# 25-53DA Home Depot

## Staff Report

<b>Address:</b>	204 Chillingham Ave
<b>Request:</b>	Request for relief from Chapter 87 Sec. 3.5.3.B.5 for wall sign standards, Chapter 87 Sec. 3.7.5.C.2 for divider median landscaping, and Chapter 87 Sec. 3.9.3.8 for lighting pole height
<b>Owner:</b>	2001 Laurel LLC
<b>Applicant:</b>	Home Depot USA, Inc.
<b>Agent:</b>	Jackson R. Boone, Esq., Boone Law Firm
<b>Parcel ID:</b>	0380-02-0001
<b>Parcel Size:</b>	±11.29 acres
<b>Future Land Use:</b>	Mixed Use Corridor
<b>Zoning:</b>	Commercial General
<b>Comprehensive Plan Neighborhood:</b>	Laurel Road
<b>Application Date:</b>	August 6, 2025
<b>Associated Petition:</b>	25-51SP and 25-52CU

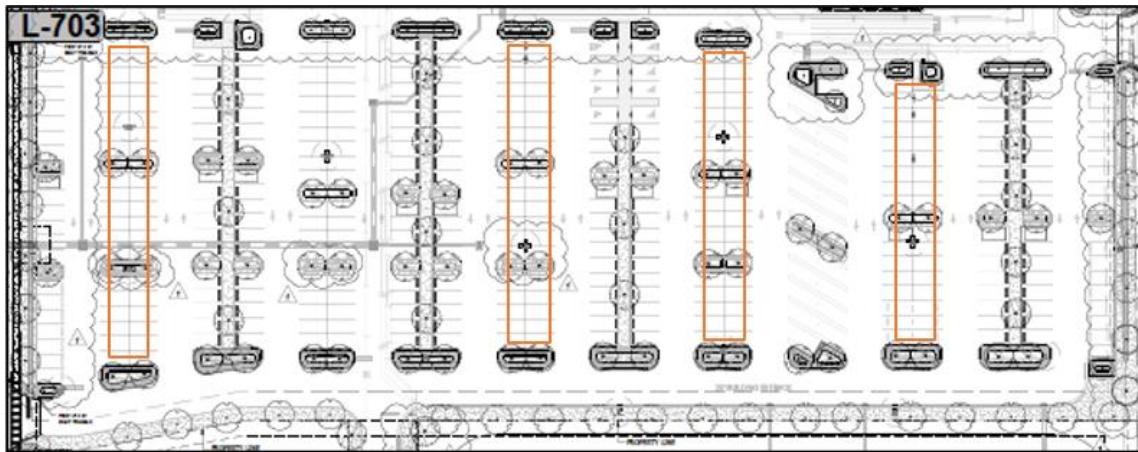
- Chapter 87 Section 3.7.5.C.2. requires landscape divider medians for all abutting rows of parking. While landscape divider medians are provided for many of the abutting rows of parking, a design alternative is requested for relief from the requirement due to the unique nature of services provided within the parking areas including a seasonal sales area, pro parking area, and rental vehicle area. Note: these areas are located within the parking lot and therefore affect the design of the parking, including the provision of divider medians, but they are provided in addition to the minimum parking requirements. For instance, landscape divider medians would be provided for every other row of parking in the main parking lot fronting the building; however, one is not provided in the angled row of parking designed to accommodate vehicles pulling trailers, which is an efficiency and safety design feature for the parking lot.
